CONSTRUCTION SUMMARY

Summer Ridge Estates Inc.

LOT NUMBER	PHASE	HOUSE TYPE	CLOSING DATE
007 BLOCK 290	1	FRENCH ROSE (25-04 B 4) ELEV B 4 BEDROOM	03-Feb-26

BLOCK 290 - TH. 7 25-04 FRENCH ROSE EL. B 4 Bedrm. 2385 SQ. FT.

OPT. UPPER LEVEL
ELEV. B
4 BEDROOM LAYOUT

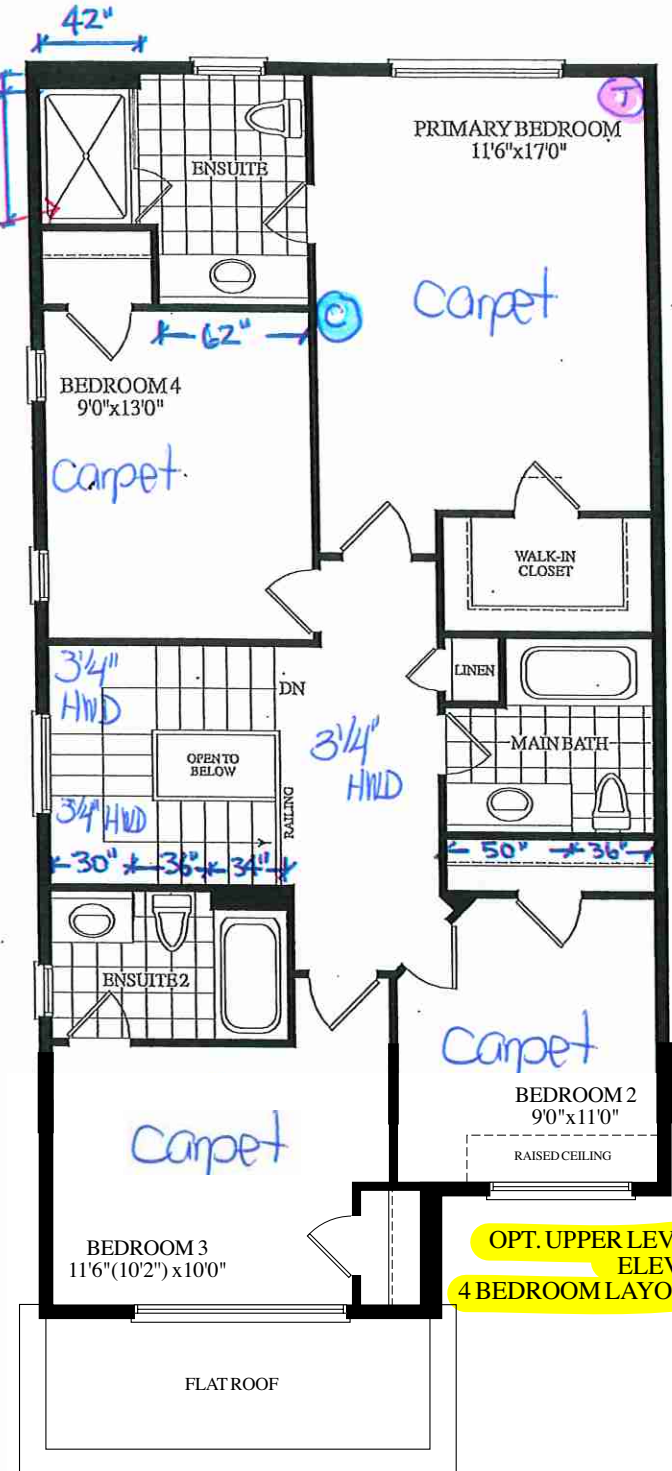
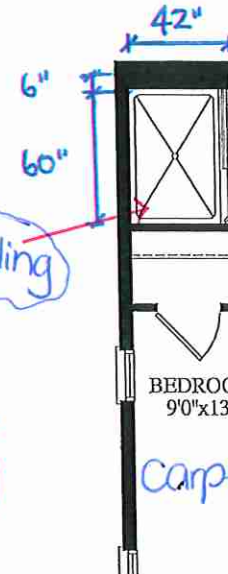
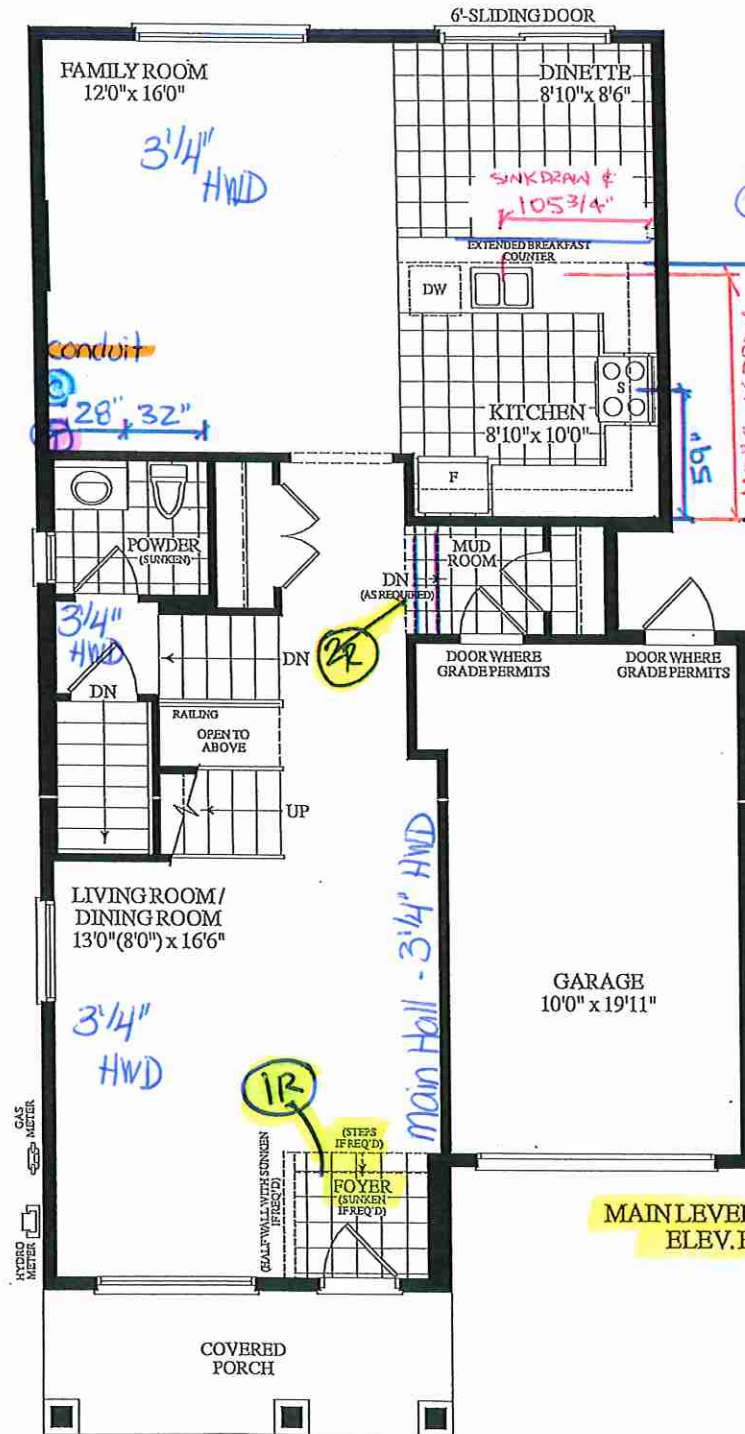
1 - Install Standard Cable Rough-Ins (x2) and Install Standard Telephone Rough-Ins (x2) (See Sketch) Note:
1 - MAIN FLOOR & UPPER HALL - FLOORING - HARDWOOD - Install prefinished 3 1/4" x 3/4" VINTAGE RED OAK TITANIUM (Select V) (Pearl) in lieu of builders standard prefinished 3 1/4"x 3/4" Vintage Red Oak Natural Hardwood. Note: To be installed throughout main floor and upper hall, where applicable. To Include; LivingRoom/DiningRoom, Main Hall, Family Room, Upper Hall and Applicable Landings (See Sketch)
1 - STAIRCASE - Stain Oak Staircase from Main Floor to Second Floor, where applicable. To be Stained - Vintage Red Oak TITANIUM - To Include; Treads, Risers, Handrail and Post, where applicable (See Sketch) Note:
1 - STAIRCASE VS FLOORING STAINING DIFFERENCE: STAIRCASE - The purchaser was advised and therefore accepts and acknowledges that the stain of the staircase and flooring chosen do not match. This difference might result in an undesirable colour variance. Note: The purchaser agrees that the vendor is to be exempt from any and all claims by the purchaser regarding this colour variance.

Cable (x2)
Telephone (x2)
Conduit (x1)
